From:	Robert Wales <rawales@gmail.com>
Sent on:	Friday, February 21, 2020 3:10:15 PM
To:	Dermody, Bill (CI-StPaul) <bill.dermody@ci.stpaul.mn.us>
Subject:	RM Zoning Study Comments

I'd like to make the following recommendations and comments on the RM Zoning Study Code Amendments.

6 Oakley Avenue

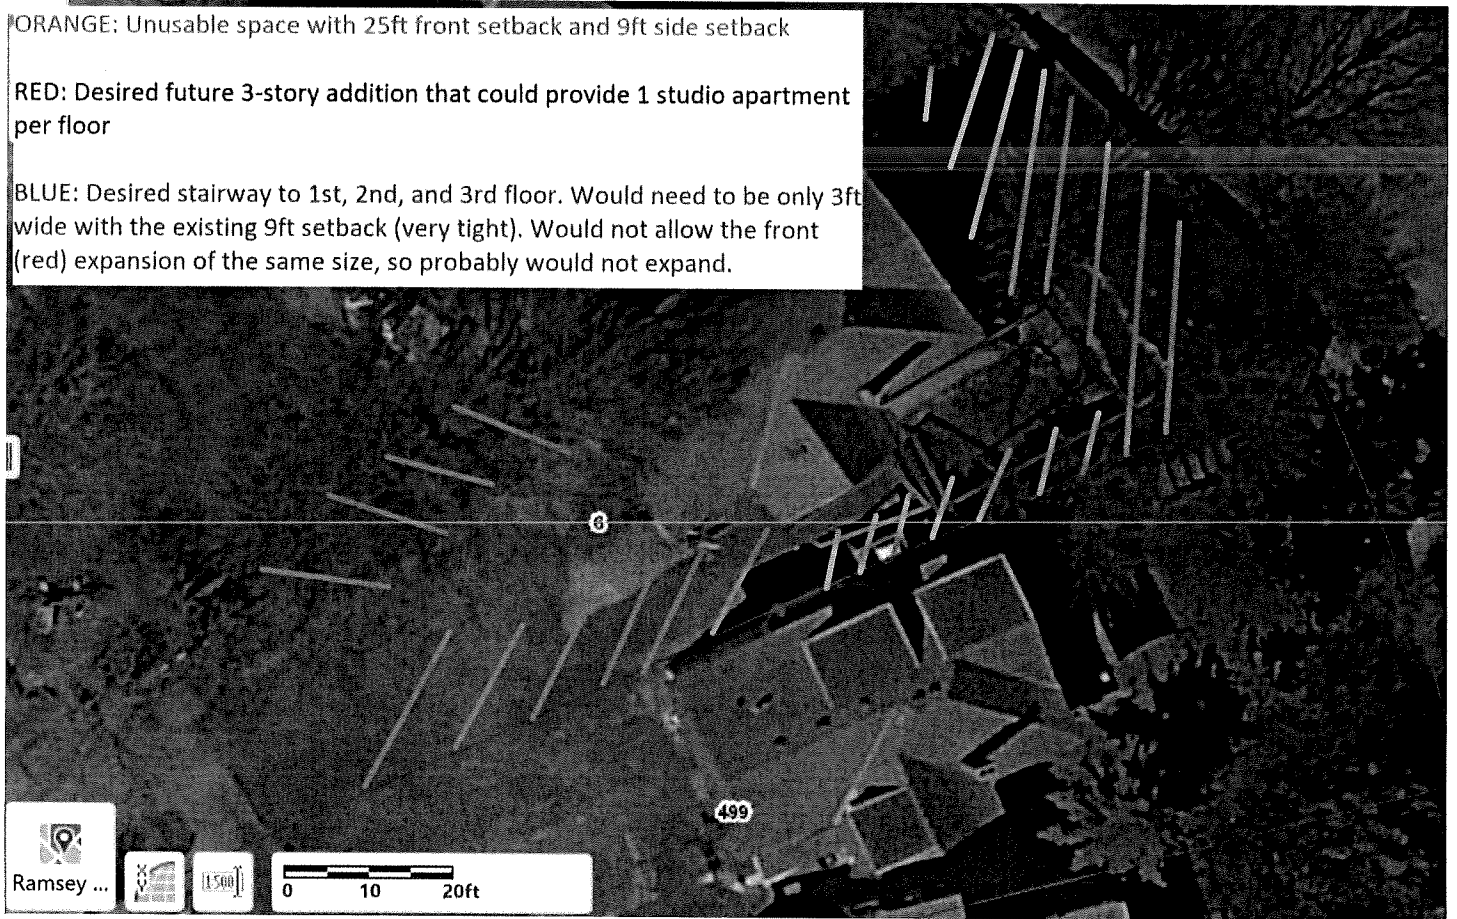
ORANGE: Unusable space with 25ft front setback and 9ft side setback

RED: Desired future 3-story addition that could provide 1 studio apartment per floor

BLUE: Desired stairway to 1st, 2nd, and 3rd floor. Would need to be only 3ft wide with the existing 9ft setback (very tight). Would not allow the front (red) expansion of the same size, so probably would not expand.

I was hoping to be able to use some of my front and side yard to expand the building to provide more housing. A reduced front setback would more easily allow me to add a 2nd and 3rd floor deck off the front of the apartments that overlook Iris park directly ahead (which would be an attractive feature).

If a 9ft side yard setback remains in place, the most I could expand in the red outline is about 11ft to the side and 10ft to the front because I would need additional space in the blue area for a 6ft wide (minimum) stairway. This would mean that the addition to the building would not accommodate any additional units and not be worth the investment.

1612 Van Buren Avenue

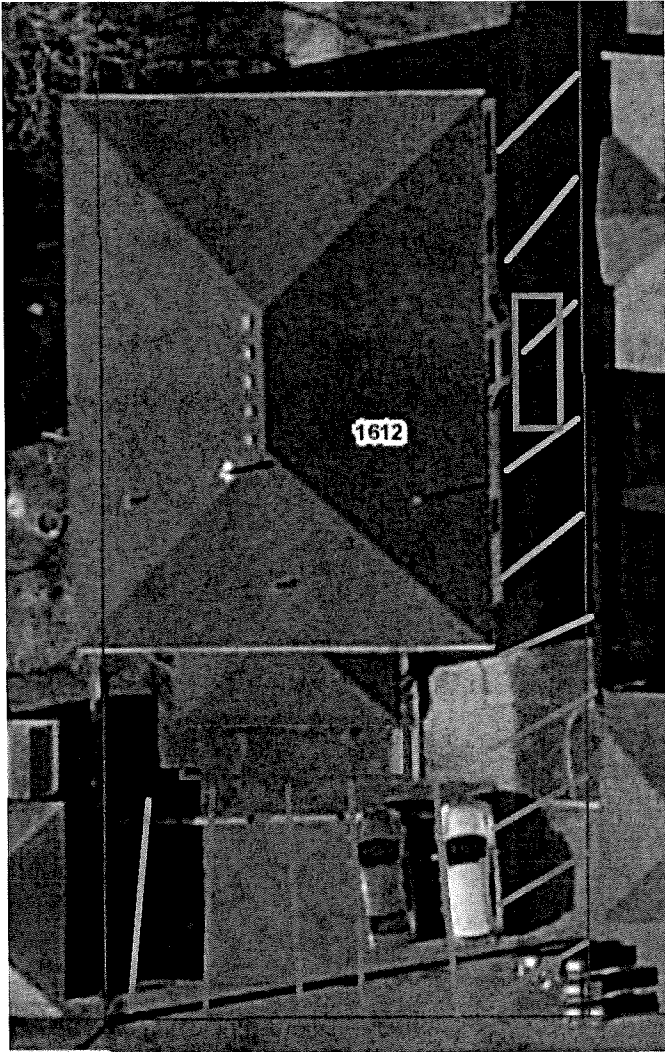
The orange lines show how the 9ft side and rear-yard setback eliminate the possibility expansion.

The blue boxes indicate where I'd like the option of building steps/decks to the 1st and 2nd floors to accommodate additional apartments. I have no option on the side yard, and have a very tight fit on the rear and would likely need to request a variance of a few feet unless I want to try to create a crazy spiraling staircase in the space off to the right and a narrow walkway along the back, which would be ugly.

1247/1249 Blair Avenue

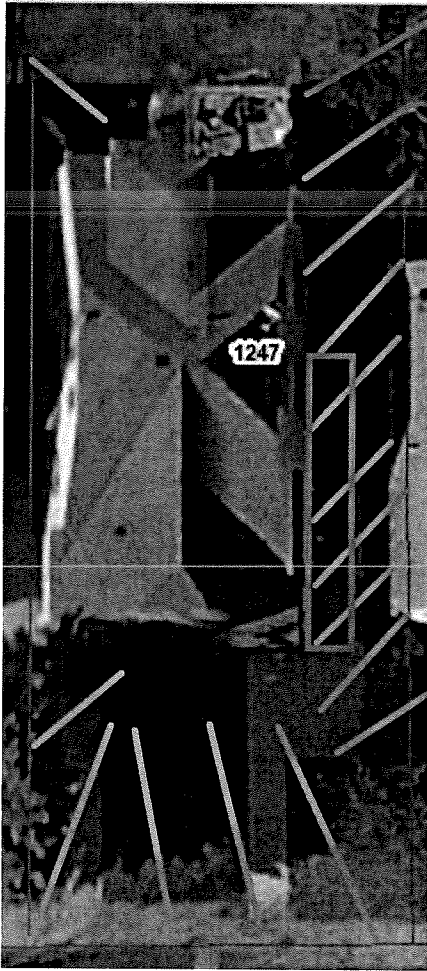
You can see that the side yard setback would not allow me to build a straight stairway to the 2nd floor. The 2nd best option would then seem to be in the front with a roof dormer addition, raising costs
